Re: Final -TAC Application Letter of Intent for the Property Located at 3100 South Ocean Drive, Hollywood, Florida (Application No. 18-DJPV-60)

SUBJECT: Site Plan Review for an approximate 62,000 sq. ft. grocery store (Publix on the Beach).

APPLICANTS MUST ADDRESS ALL COMMENTS AND FINDINGS AS IDENTIFIED BY MEMBERS OF THE TECHNICAL ADVISORY COMMITTEE BOTH IN WRITING (IDENTIFY PAGE NUMBER OF THE CORRECTION) AND ON THE SITE PLAN (ALL CHANGES MUST BE IDENTIFIED, I.E. BUBBLED).

EXTERIOR ELEVATIONS

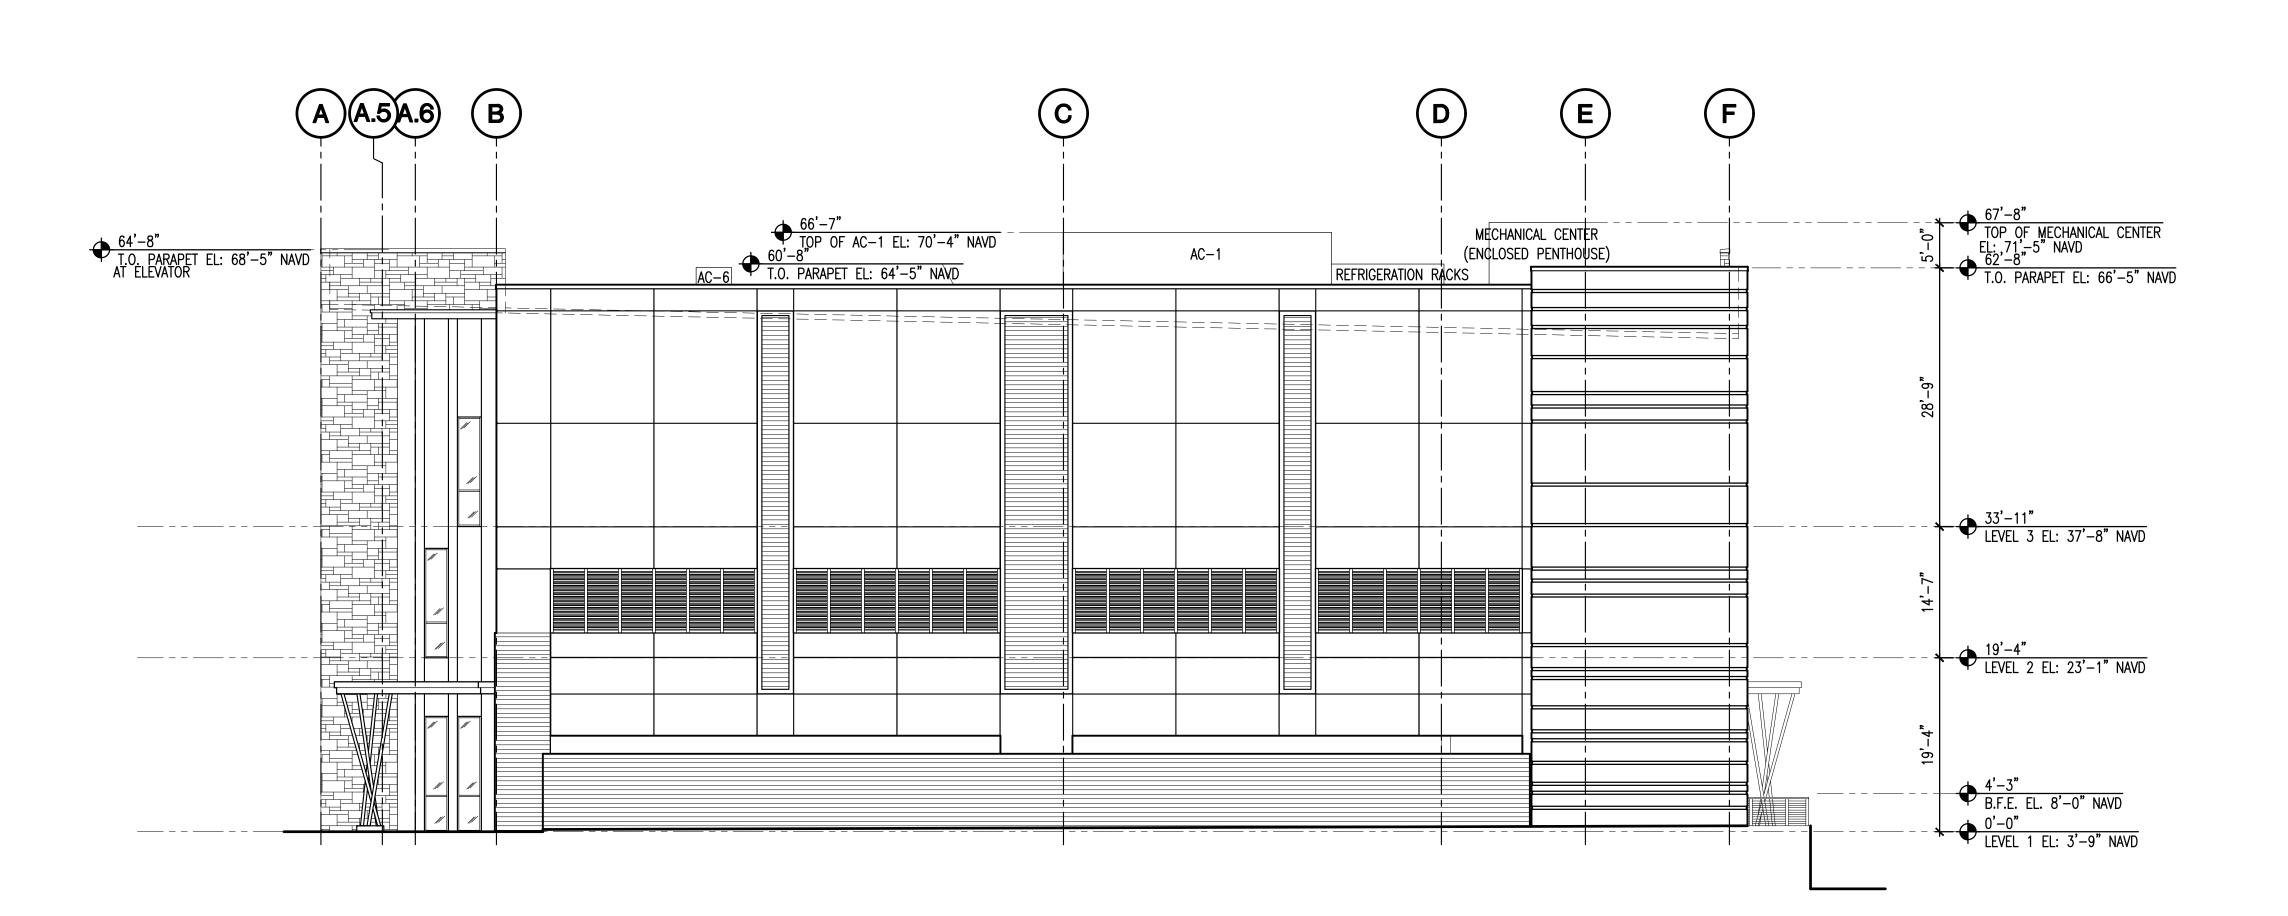
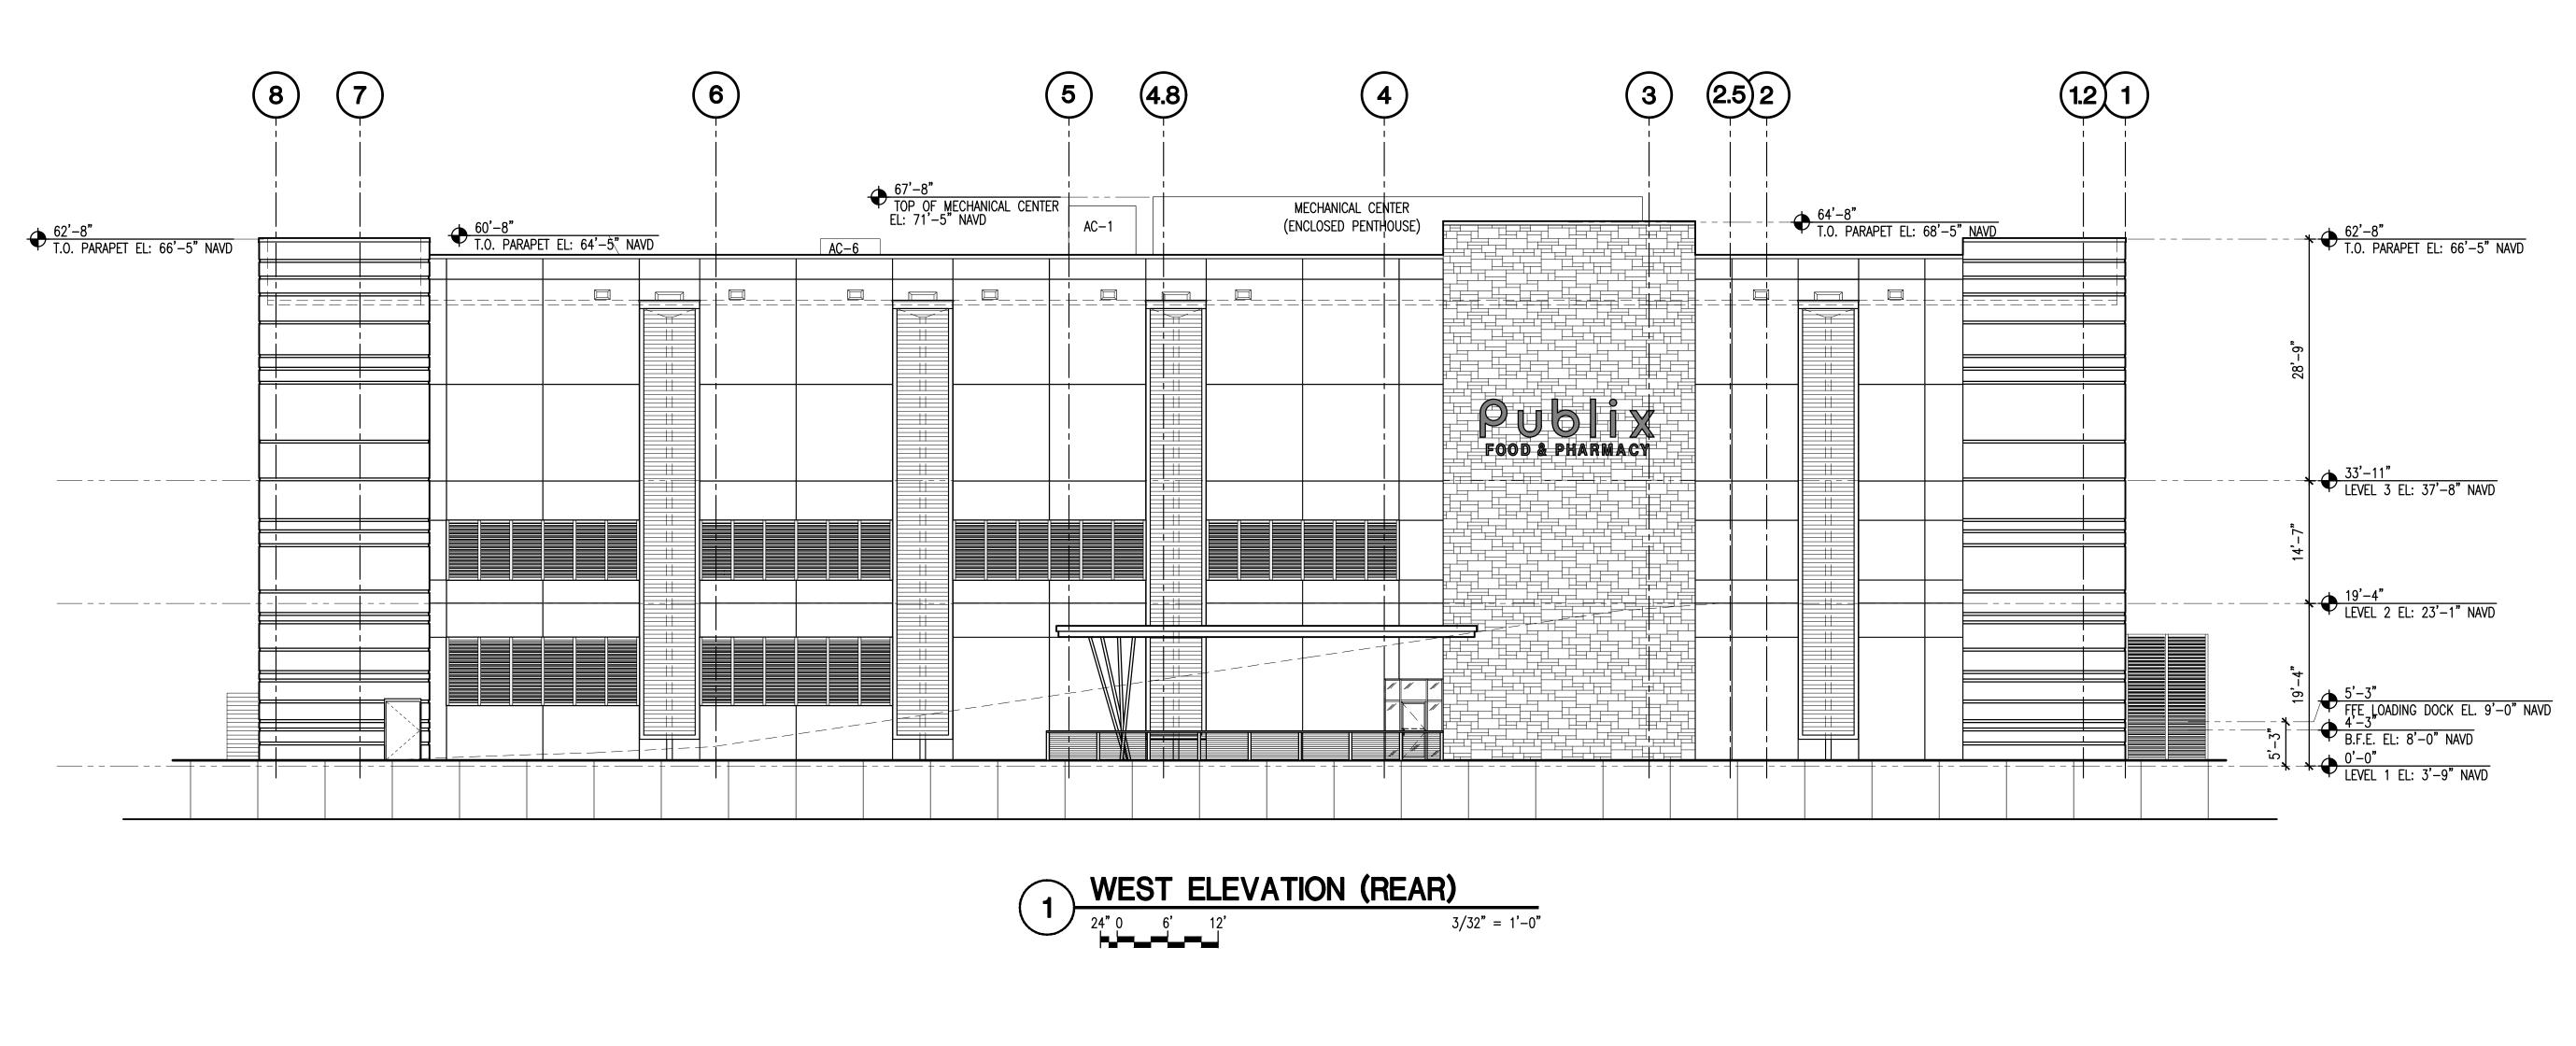
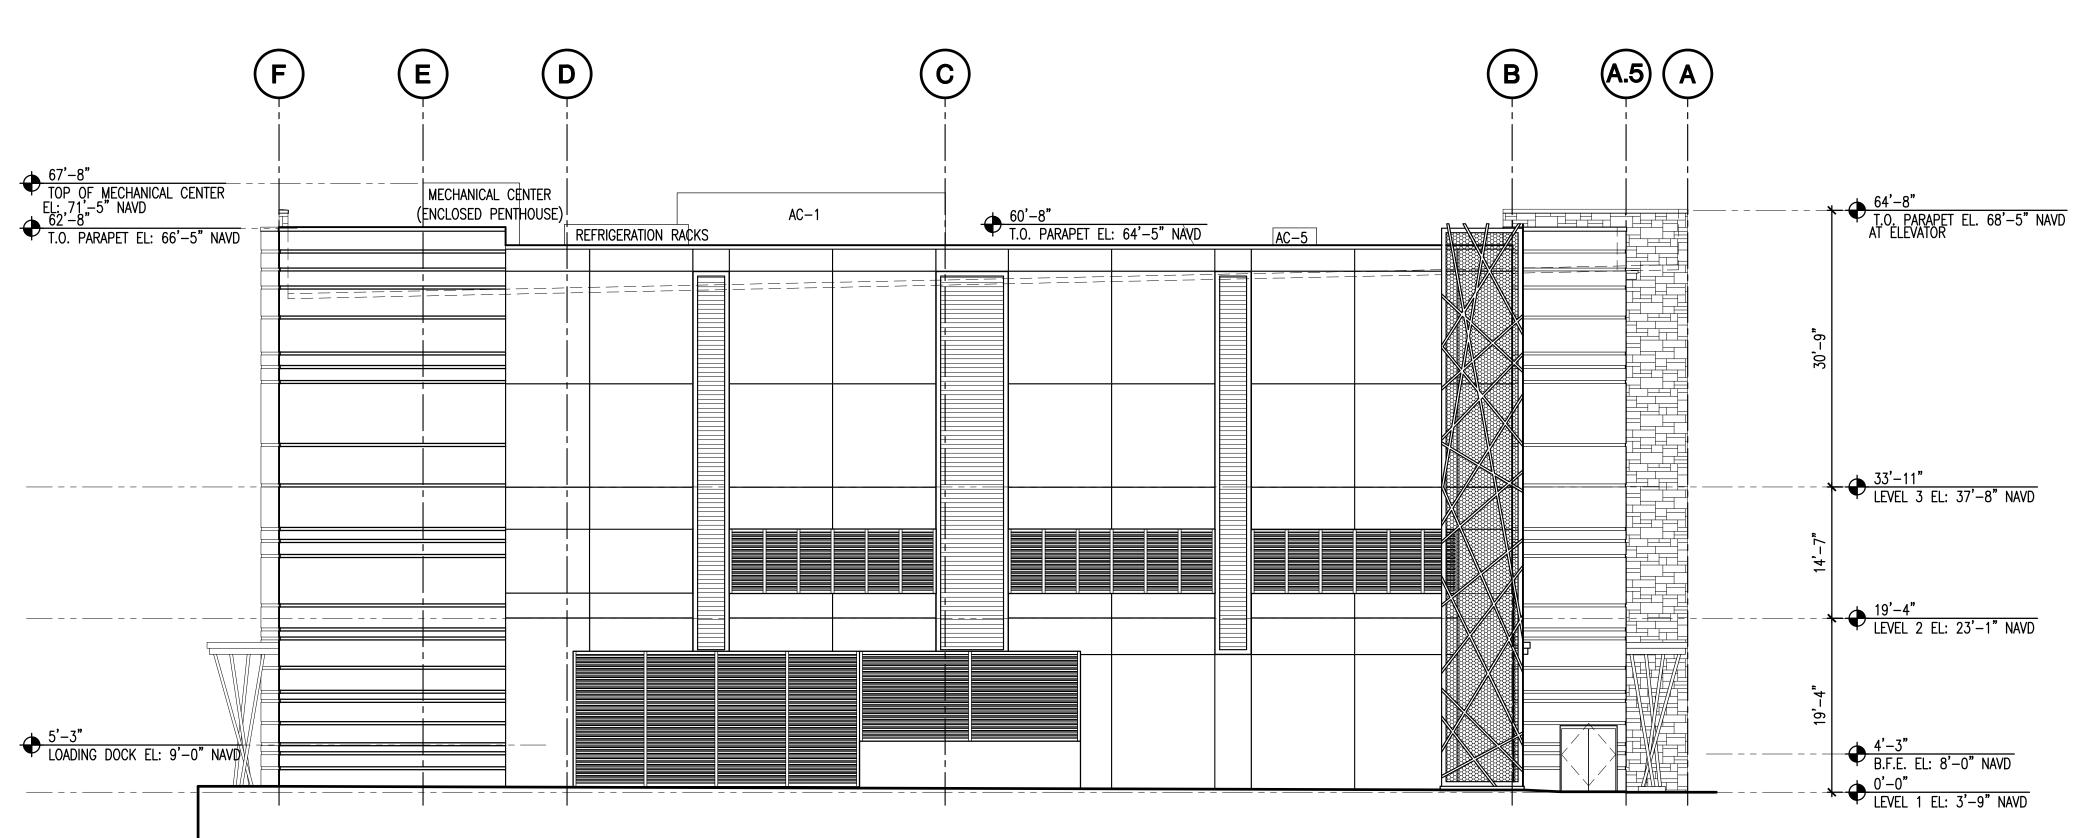
1. Sheet A4.1/A4.2 – upper portion of north/south/west elevations need additional architectural treatment.

Response – Acknowledged, we have further articulated the elevations on A4.1 and A4.2.
